DEPARTMENT OF NATURAL RESOURCES

RE: Bridgeton Landfill, LLC, Permit Number 0118912, St. Louis County
Bridgeton Landfill North Quarry Contingency Plan – Part 1 and 2,
Subsurface Smoldering Event

Based on the Department's review, the Contingency Plan – Part 2 and Revised Part 1 are not approved as written; however, several conditional approvals are being provided for specific sections to allow for ultimate finalization of contingency measures and those sections are identified and discussed further in the following comments. In addition, with this letter the Department considers the contingency plan trigger criteria and trigger lines approved as per pages two through six of this comment letter.

**Sheet 1
Trigger Line 2 Location**

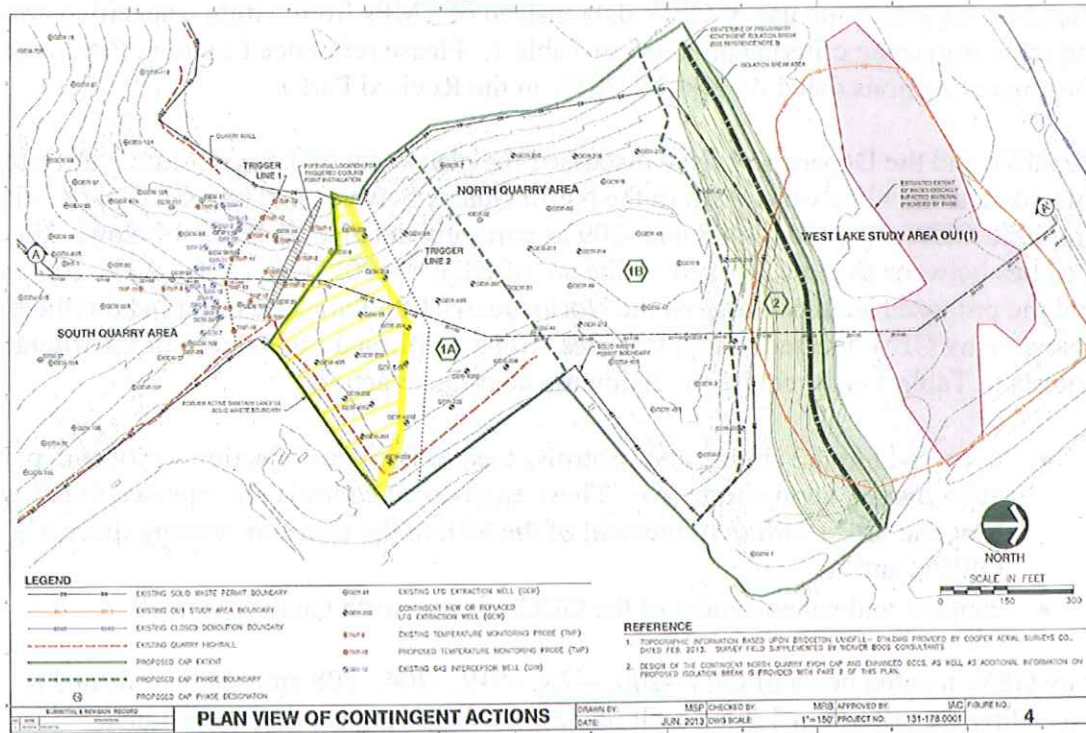
Republic and the Department have discussed the placement of Trigger Line 2. As a result of this discussion, a line was drawn in the North Quarry between existing GEW-42R, -54R and proposed GEW-200, -204, -208 and -209 as currently detailed on Sheet 1 below. The trigger area lies between the line, formed by the arc of GEWs -200, -42R, -54R, -204, -208 and -209, and the proposed southern edge of the North Quarry Cap Part 1A as detailed on Sheet 1 below. Any GEW located within that area with a confirmed exceedence of the trigger criteria in Table 1 will require the following contingent actions:

Any GEW located north of GEW-200, -42R, -54R, -204, -208 and -209 confirmed as exceeding the criteria in Table 1 will require the following contingent actions:

The placement of Trigger Line 2 is acceptable to the Department. Per the contingency plan requirements, additional GEWs are to be installed in the North Quarry Area 1A if trigger criteria are exceeded in Trigger Line 1. As the Area 1A GEWs help complete Trigger Line 2, it is essential that they be installed timely to provide adequate spacial coverage.

Note: GEWs in the yellow area exceeding the criteria in Table 1 require additional engineered controls and capping and enhancement of the GCCS in the North Quarry Area - 1B. Any GEW located north of GEW-200, -42R, -54R, -204, -208 and -209 and confirmed as exceeding the criteria in Table 1 require installation of the isolation barrier and capping of North Quarry Area 2.

Mark-up of Table 1 from the Revised Plan 1

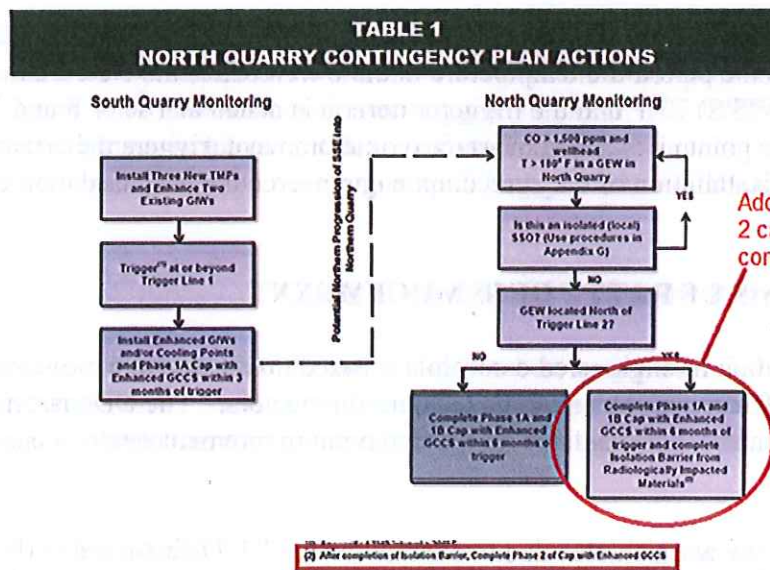
- Table 1 of the Revised Plan 1, needs to explicitly state in the applicable box that part 2 of the cap will be installed in addition to 1A and 1B upon completion of the isolation barrier construction.
